# AVIATION AUTHORITY

Rebuild and expand single family home after flood damage

**AVIATION AUTHORITY**  
**\* PETITION FOR VARIANCE \***

# Review Summary

## Exhibit A

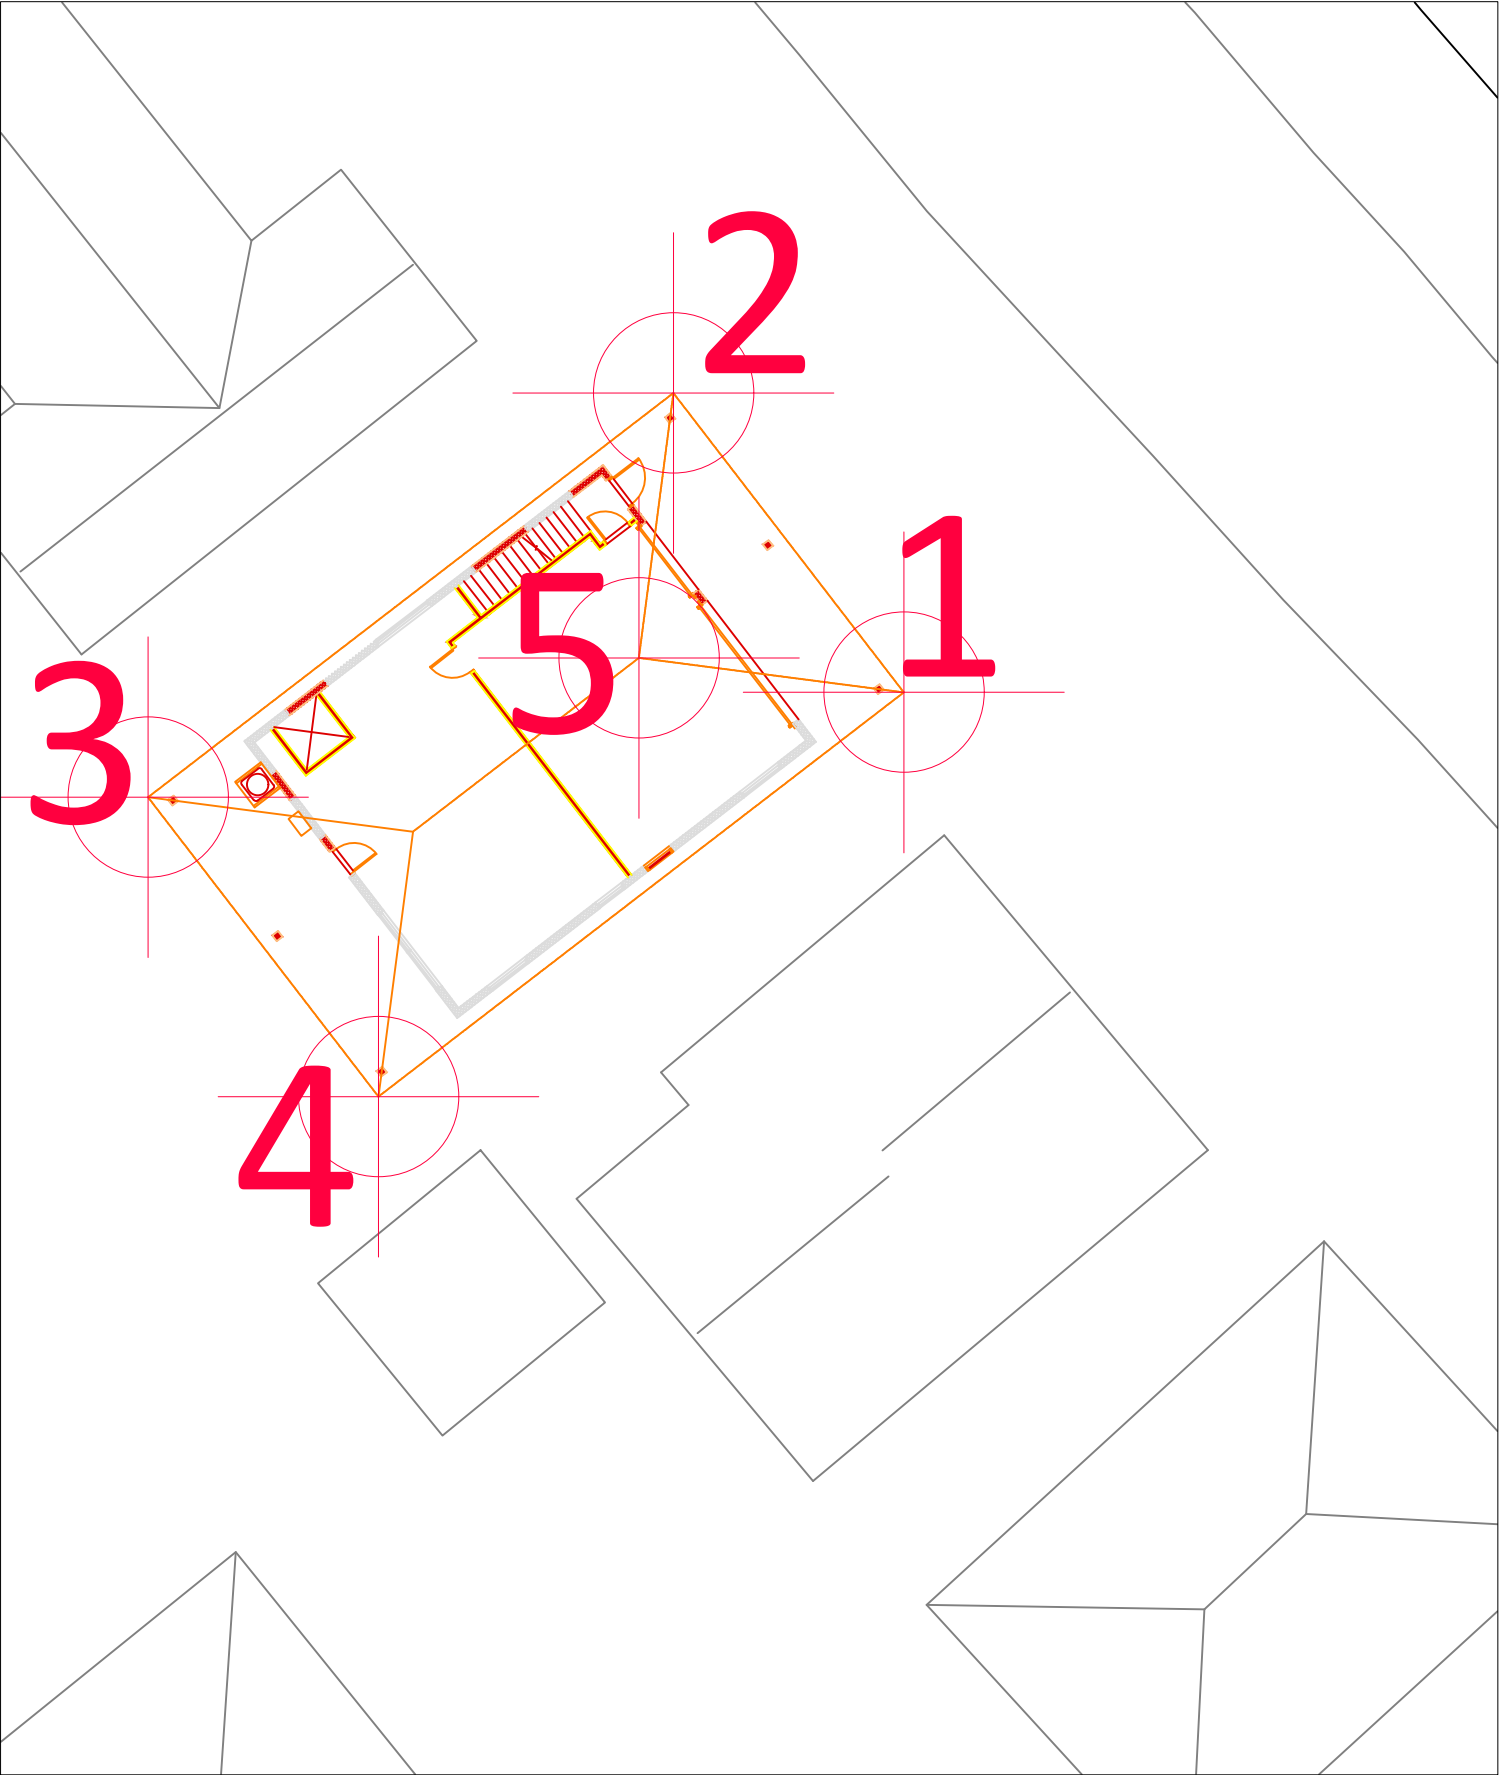
The project is subject to requirements listed in the attached Federal Aviation Administration Aeronautical Studies with the exception that height limits are restricted to the heights shown on the point data sheet attached as Exhibit A and in accordance with elevation plans submitted.

# Part 77 - Approach Transitional

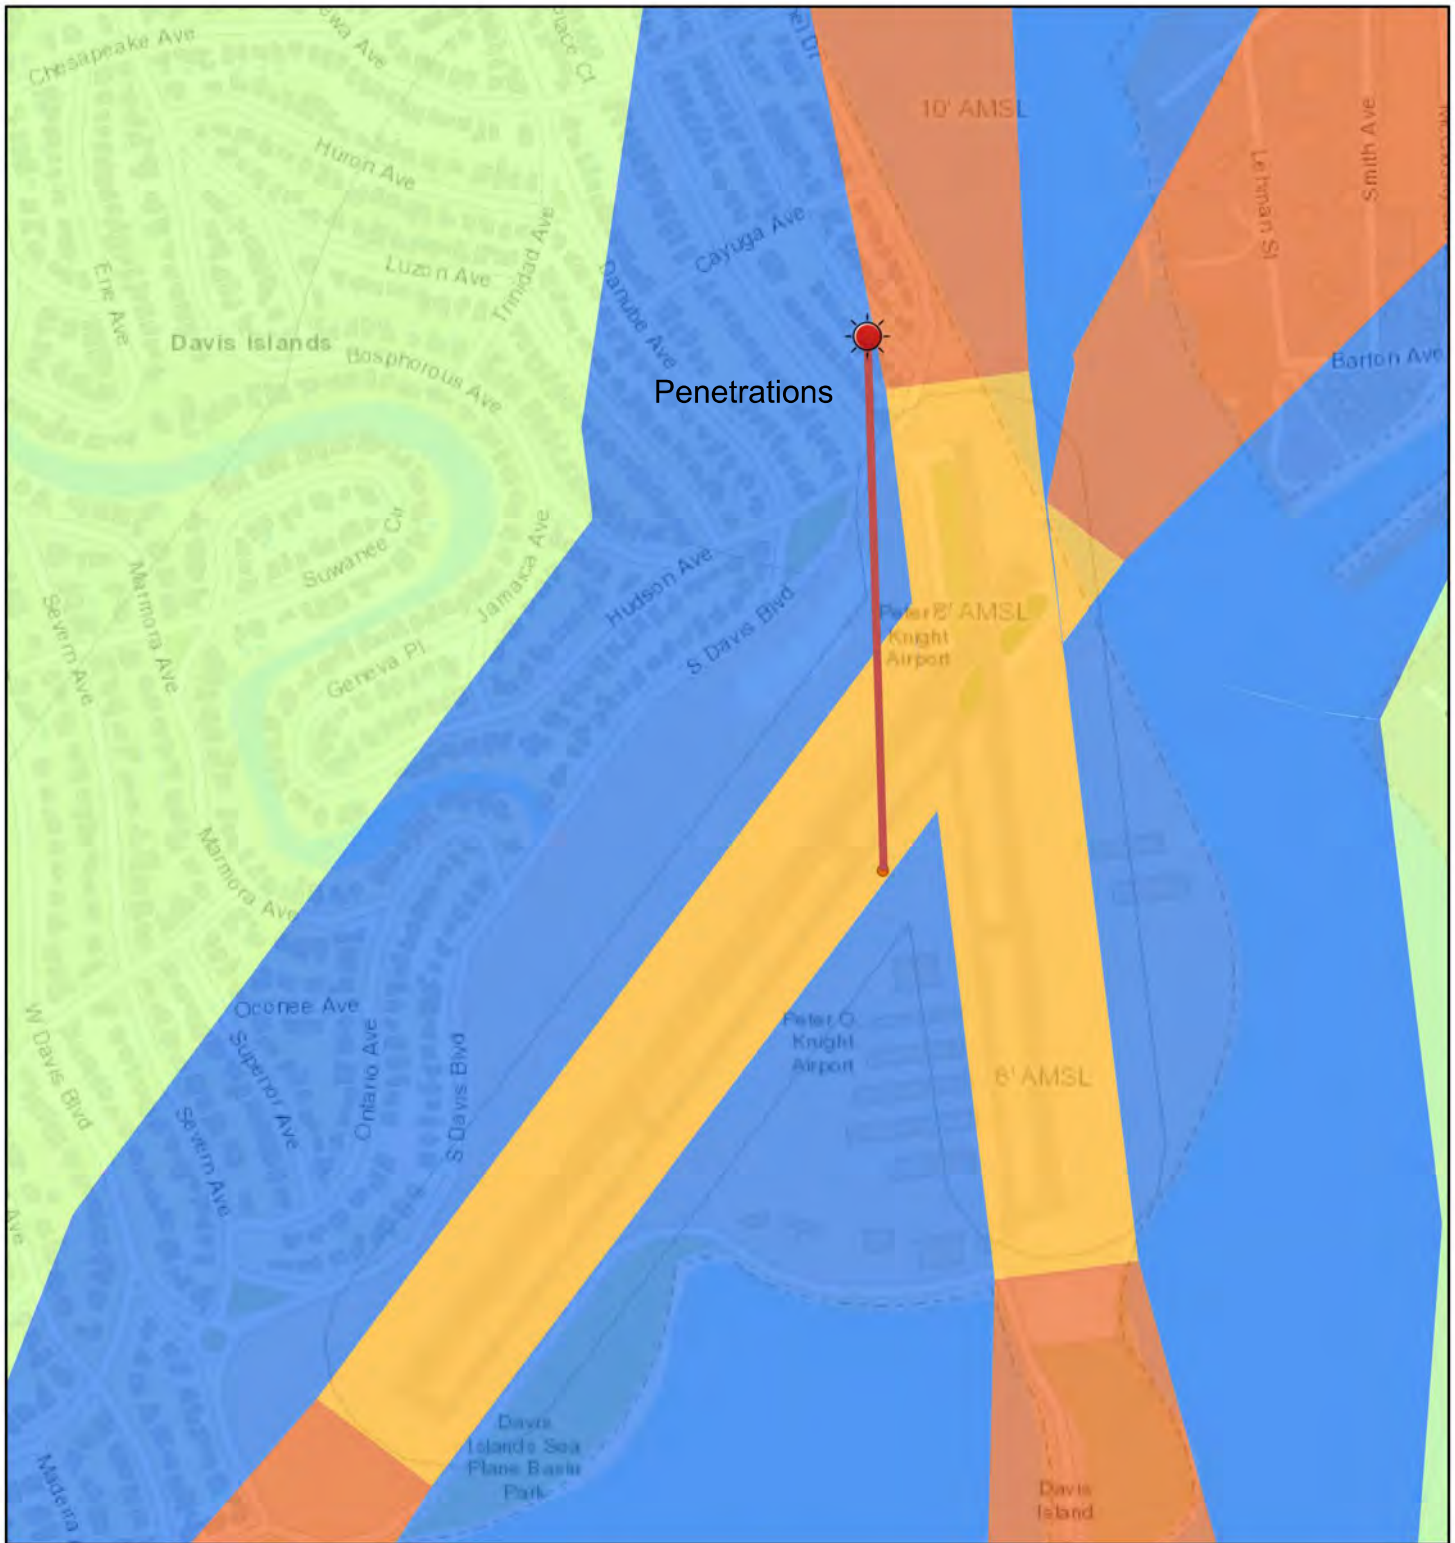
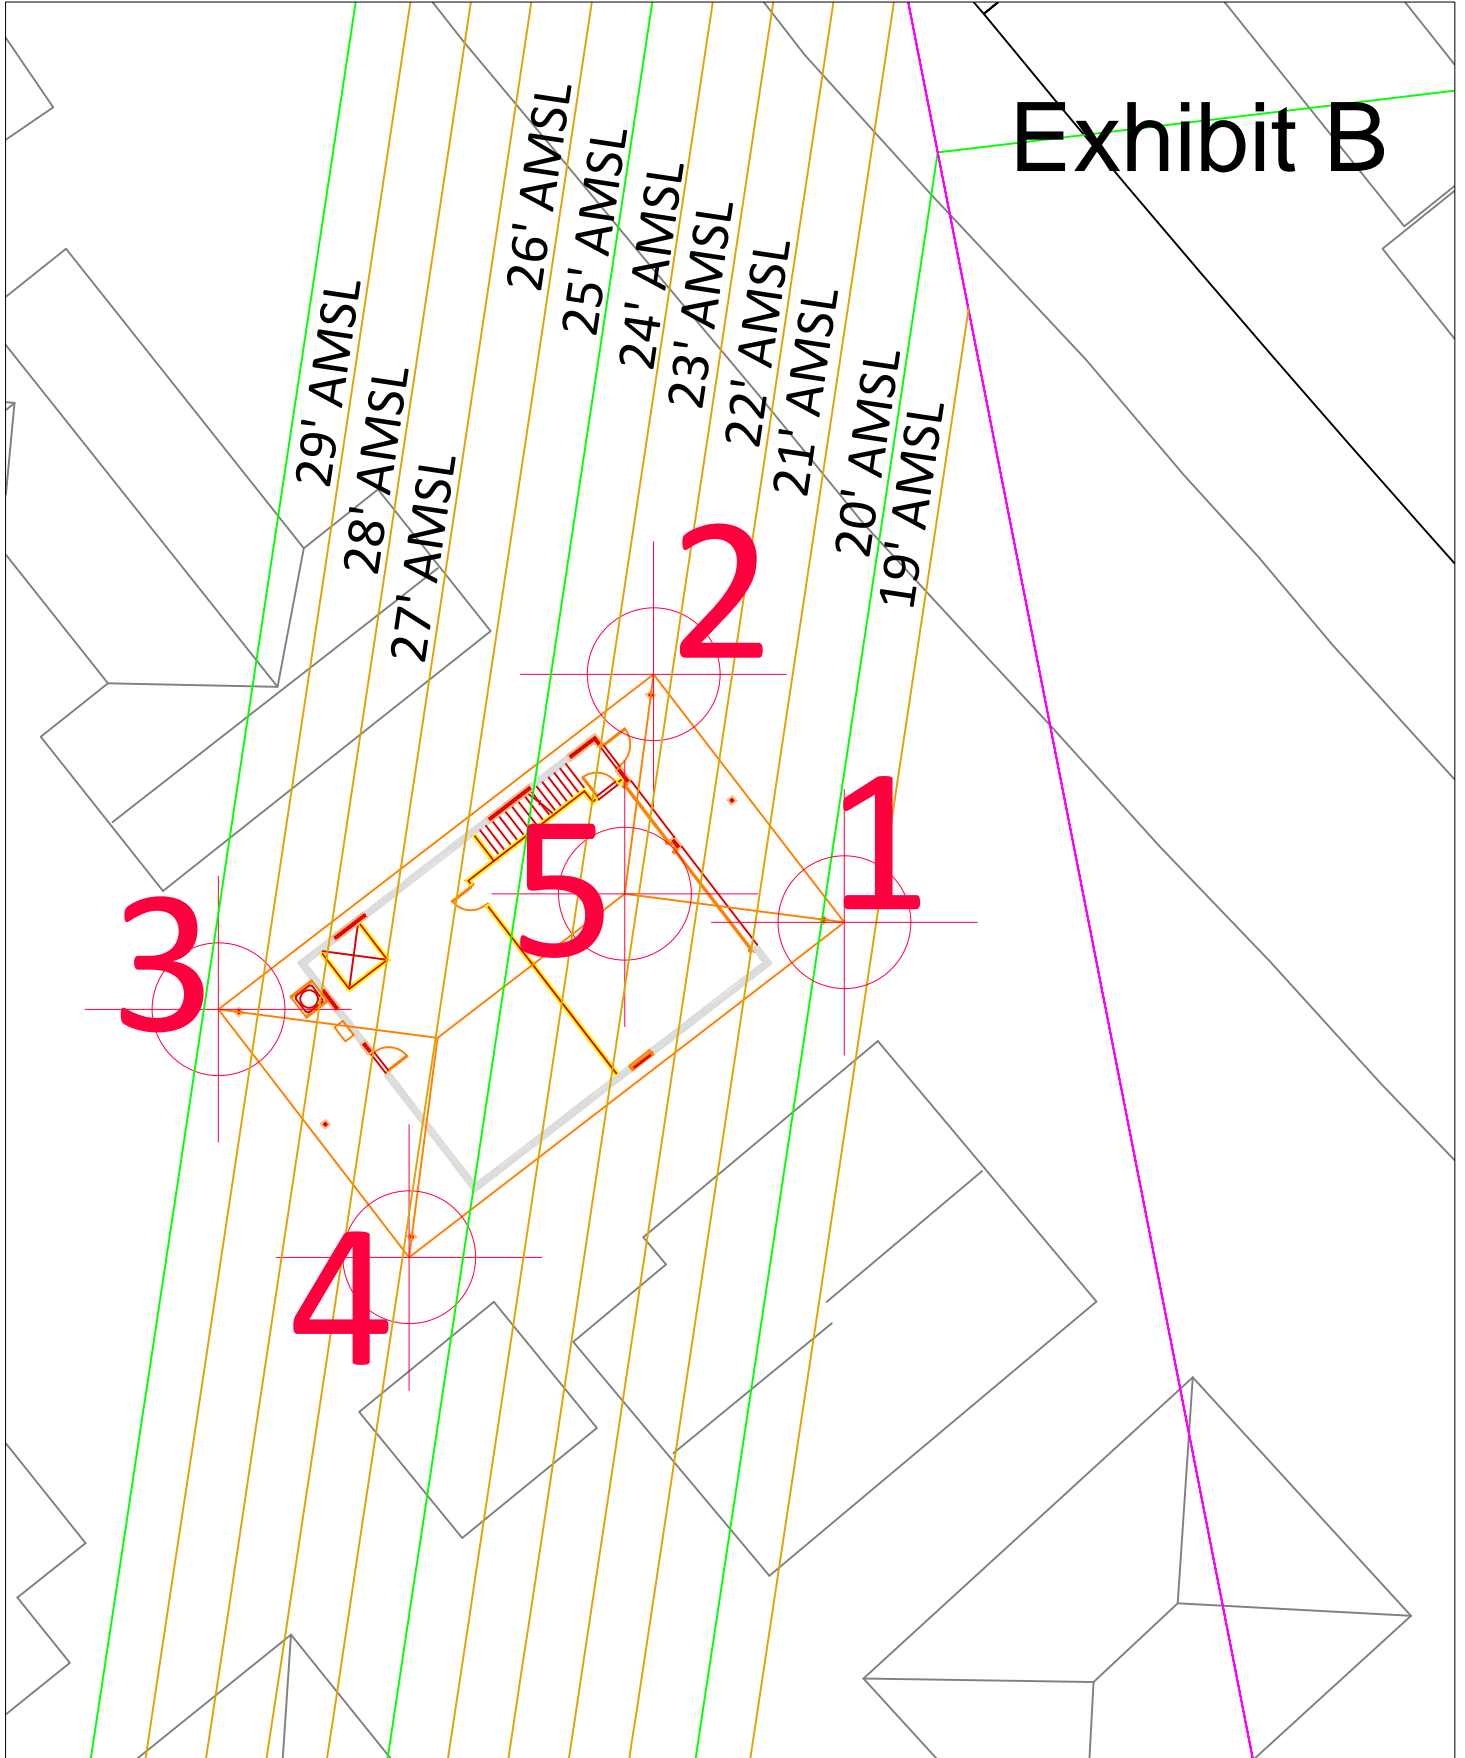
Structure penetrates the Approach Transitional Surface to Runway 18 by Approx. 8' at it's highest point. No IFR or navaid impacts identified. No Hazard as long as conditions are followed.

Section 77.19 (e): Transition Surface. These surfaces extend outward and upward at right angles to the runway centerline and the runway centerline extended at a slope of 7 to 1 from the sides of the primary surface and from the sides of the approach surfaces. Transitional surfaces for those portions of the precision approach surface which project through and beyond the limits of the conical surface extend a distance of 5,000 ft. measured horizontally from the edge of the approach surface and at right angles to the runway centerline. The proposal exceeds the TPF RWY 18/36 Transitional surface by 12 ft.

Red Obstruction lighting required in accordance with the FAA Advisory Circular 70/7460-1M.

PROJECT:	618 Columbia Dr. Tampa   FL 33606
DATE:	25   013
PROJECT:	02   12   25
PROJECT:	Existing Residence   Renovation
PROJECT:	Construction Documents
PROJECT:	618 Columbia Dr. Tampa   FL 33606
SHEET TITLE:	EXTERIOR ELEVATIONS FAA VARIANCE
SHEET NUMBER:	A   2.0

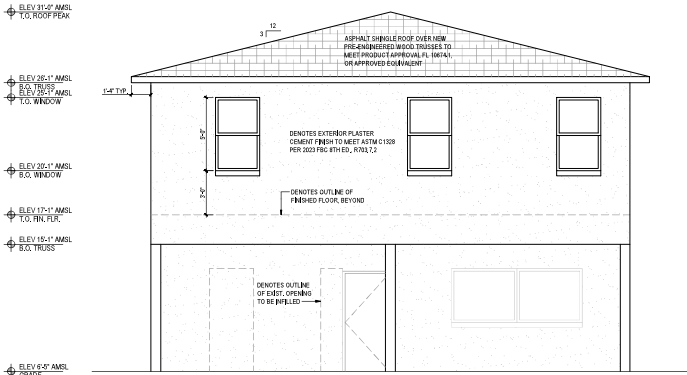
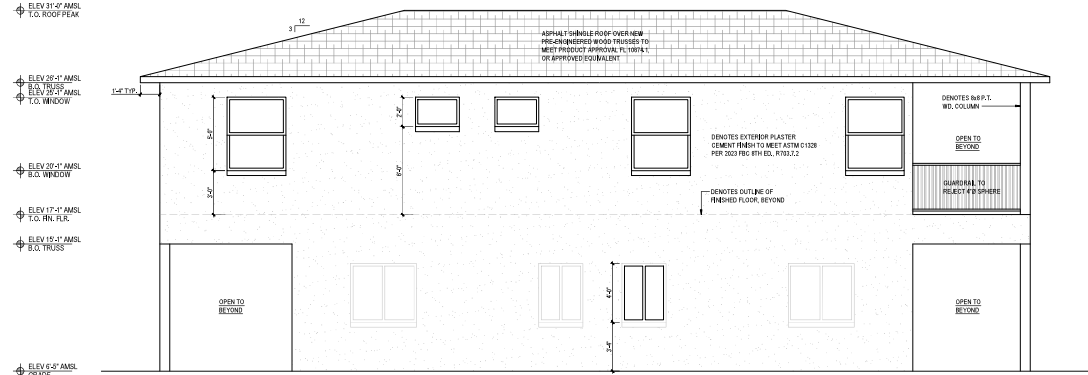
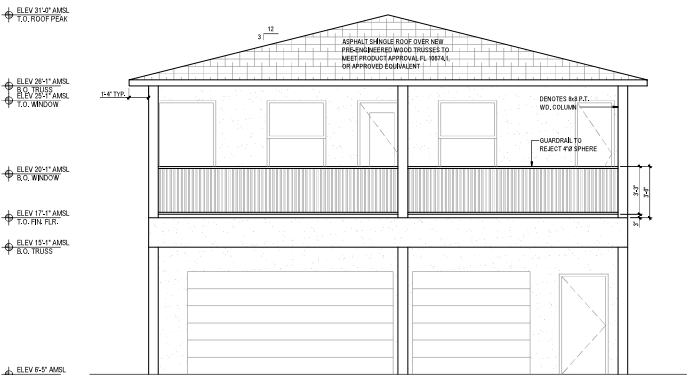
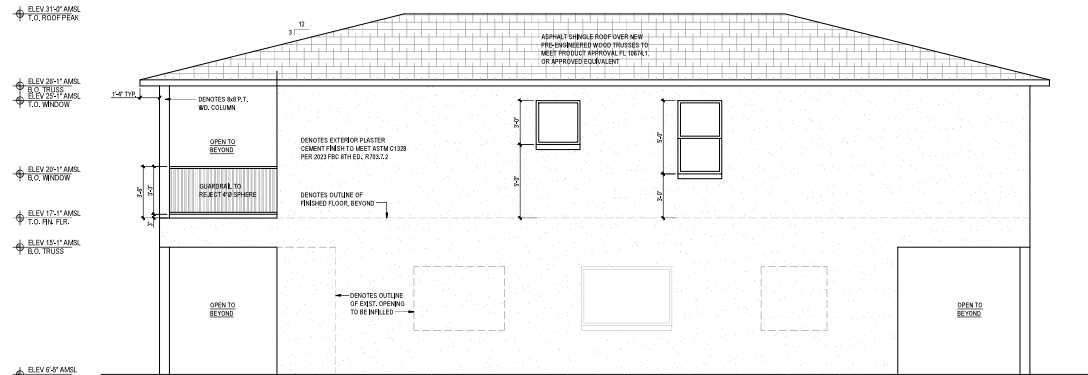
Our existing walls are 8 ft and the base floor is 6' 10" AMSL. After putting the thinnest floor trusses possible on the block wall in place of the existing pitched roof, then using a 3/12 new pitched roof, we are able to build a new house that complies with FEMA regulations at a height of 31 AMSL at the peak and 27 AMSL at each of the four corners. We have provided the plotting in Latitude and Longitude of those 4 corners and the east end of the peak, which is the closest to the approach of the runway.

Installation equipment (Crane) exceeding 31' AMSL or installation of solar panels will require a separate permit by the Aviation Authority.

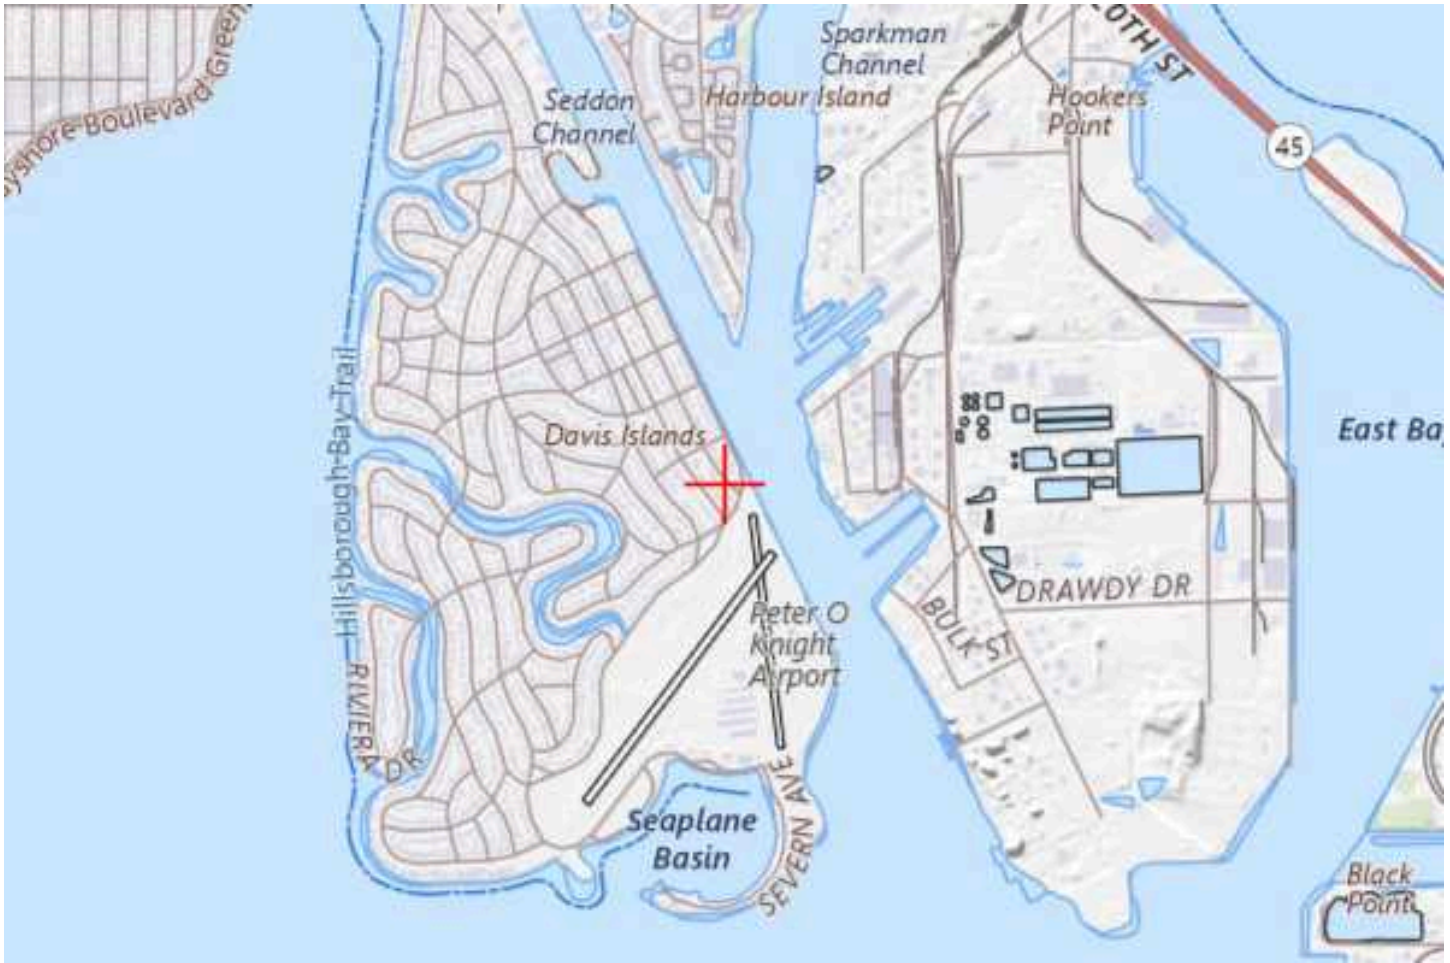
The proposal was not circularized to the public for comment as circularization for an existing structure, or previously existing structure in this case, is determined on a case-by-case basis. The proposals noted penetration to the part 77 Transition surface is not considered significant as the penetration is no greater than other existing structures previously studied by the FAA in terms of adverse effect to the aeronautical environment in the immediate area. A light pole, studied under aeronautical study number 2016-ASO-29654-OE, is existing and in closer proximity to the airport, approximately 135 ft. south of this proposal's location and in closer proximity to the approach end RWY 18 at TPF.

It is recommended the proposal be lit with landscape up lighting near the residence as well as a driveway entrance light. Existing trees, or newly planted trees should be managed on the property as to not exceed the height of this FAA determination letter.
